EMERGENCY DEPARTMENT & CANCER CENTER EXPANSION

1 CCD #8

09-26-2008 STEEL **DETAILS** 4034

DETAIL

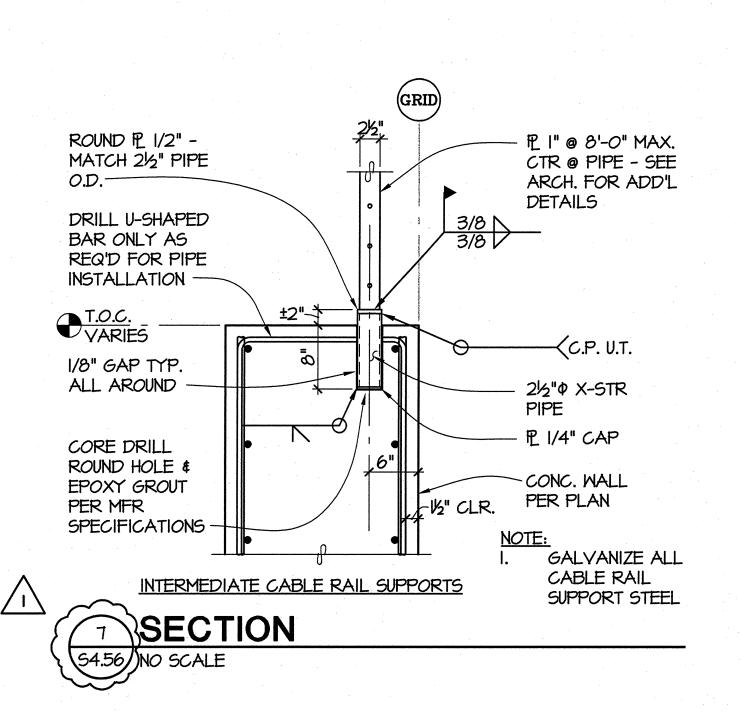
136" OUNTERBORED _ STD ROUND HOLE HOLE - TYP. PTG PER PLAN ---____P_ 7/8" _ EDGE OF CONC. COVER PL EA. SIDE - SEE ARCH. OTHERWISE COORD. W I. DO NOT CUT OR DRILL REINF. OR POST TENSIONING FL 5/16" - COORD. CONN. TO CABLES 2. COORD. PL HOLES W MFR -W (E) CONDITIONS 3. GALVANIZE ALL CABLE RAIL END ATTACHMENT STEEL 1/2" PEPOXY ANCHOR EA. INSTALL (10) ANCHORS SIDE - INSTALL (12) ANCHORS MIN. (5) ABOVE \$ (5) MIN. (6) ABOYE & (6) BELOW & BELOW & MIN. @ GRID MIN. - CUT THRD'D ROD FLUSH CABLE RAIL END SUPPORT 12 CABLE RAIL-WP 7/8" COORD. ADD'L DETAILS W ARCH. \$4.57)NO SCALE
